City of Portland, Maine – Building or Use Permit Application 389 Congress Street, 04101, Tel: (207) 874-8703, FAX: 874-8716

BUILDING PERMIT REPORT

REASON FOR PERMIT: Repair deck Enclosing deck with 3 Season Surround

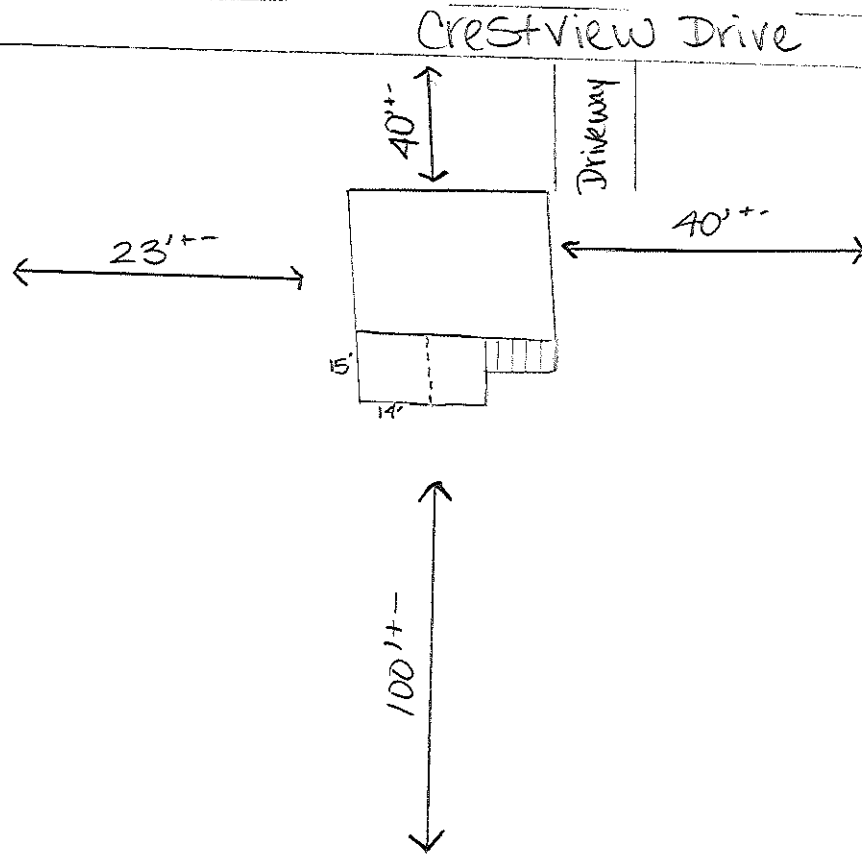
3/13/2017 call name window & sunroom there will be 8 new 16" square table added to existing deck - on footing 4' below grade - beam will also be added ~~etc~~"

A-FRAME ROOM CROSS SECTION

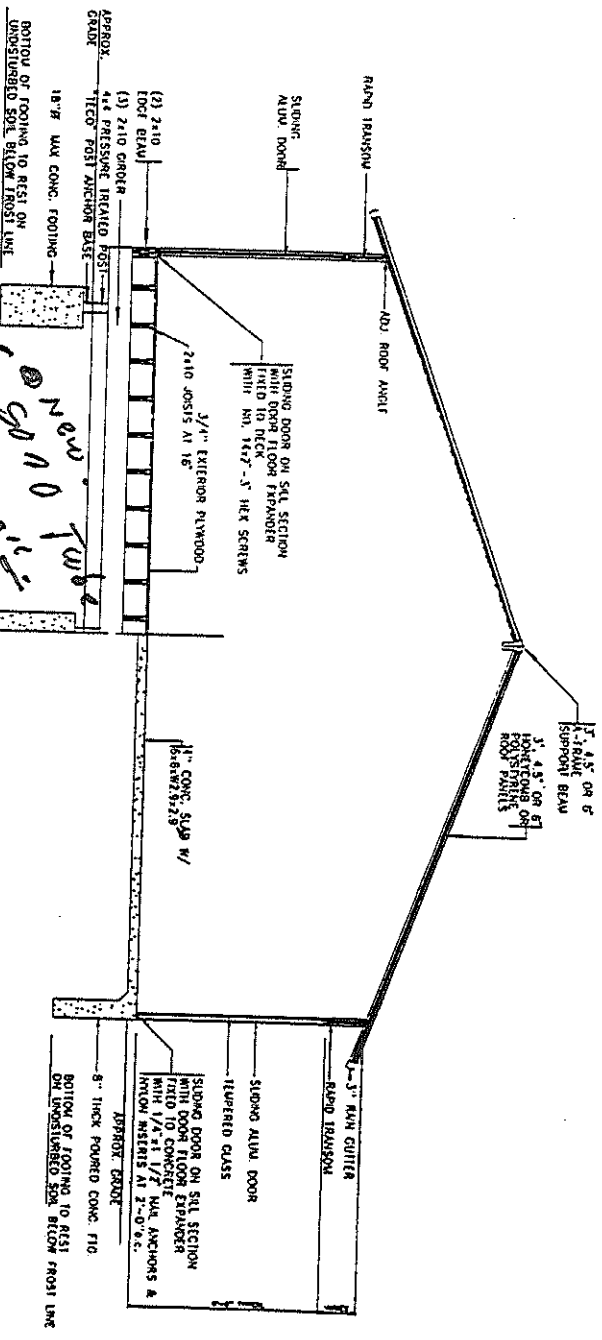
Handwritten notes:
 All 1-500-564-5858 before
 New 10" Footing 2x8
 grade on Double beam
